**TOWN OF NEWBURGH  
PLANNING BOARD  
REVIEW COMMENTS**

**PROJECT: DIXON 2 LOT SUBDIVISION**  
**PROJECT NO.: 14-15**  
**PROJECT LOCATION: SECTION 3, BLOCK 1, LOT 103.31**  
**REVIEW DATE: 5 JULY 2016**  
**MEETING DATE: 7 JULY 2016**  
**PROJECT REPRESENTATIVE: TALCOTT ENGINEERING**

Re: Dixon Subdivision II (2 Lots)  
Town Project No. 2014-15  
S-B-L: 3-1-103.31  
Job No. 13074-PEI

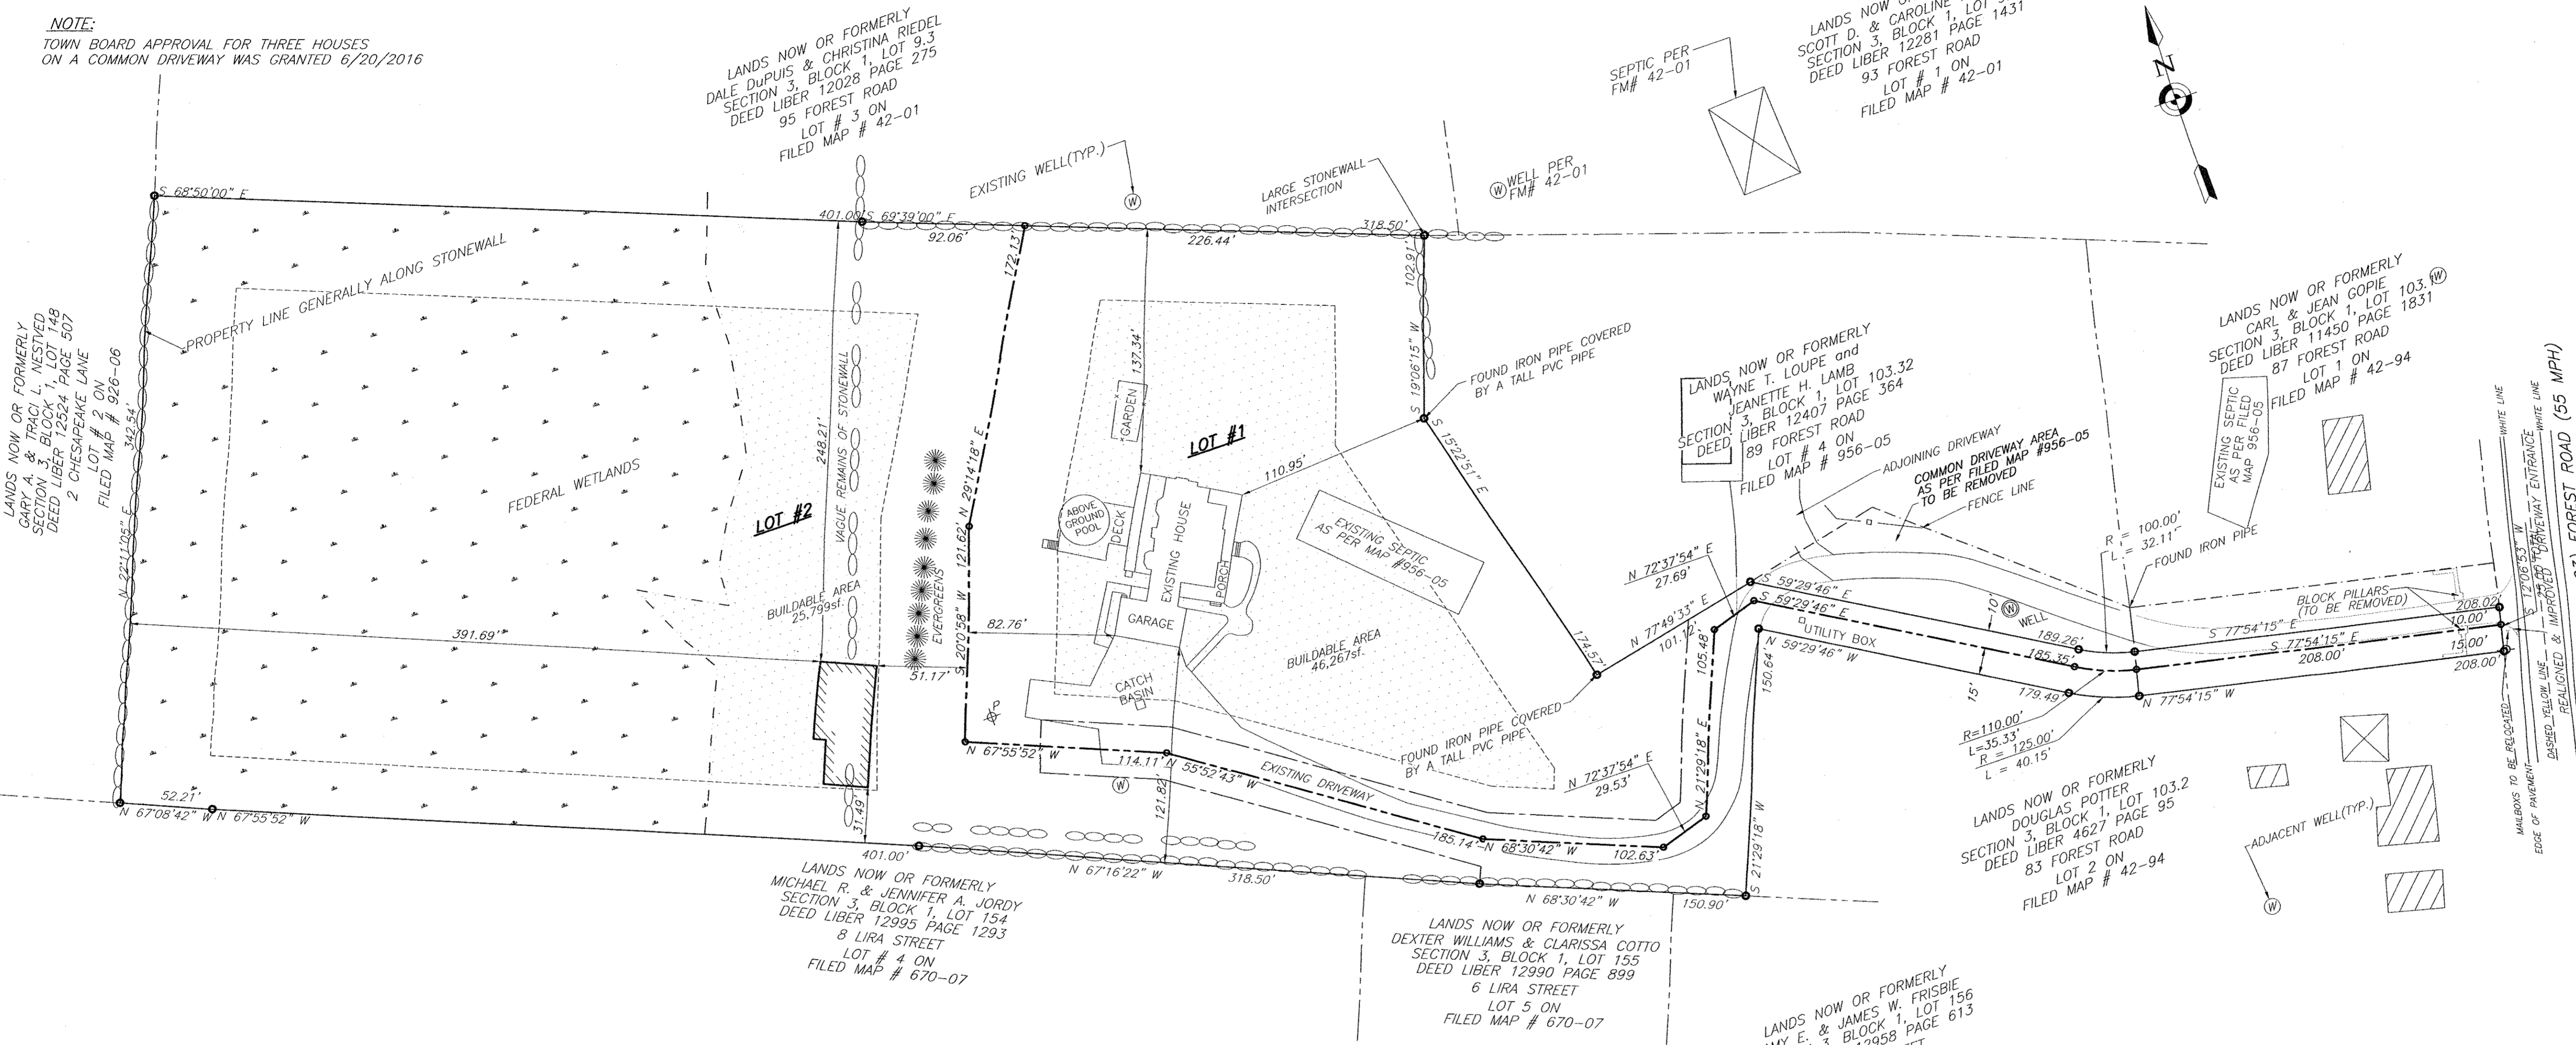
1. Portions of the driveway to be abandoned should be addressed, are they to be removed and replanted? Notes pertaining to how the driveway will be abandoned should be added to the plans.
2. Common driveway access and maintenance agreements should be provided.
3. Applicant's representative notes that Town Board granted 3 houses on a common driveway on 20 June 2016. Confirmation from Town Board minutes should be received for Planning Board file.
4. A condition of approval is noted that the well on proposed Lot #1 must be constructed prior to signing of the maps as the new proposed Lot #2 will utilize the existing well which serves lot #1. Confirmation that the well has been connected to Lot #1's existing house should be received.
4. Orange County DPW approval for the driveway should be received.

- 1) The driveway entrance to Forest Road (County Rte. 23) has been revised per the County DPW.
- 2) The driveway has been modified per the owner of S/B/L: 3-1-103.32
- 3) Town Board approval granted for 3 houses on a common driveway is noted on Sheet 1.
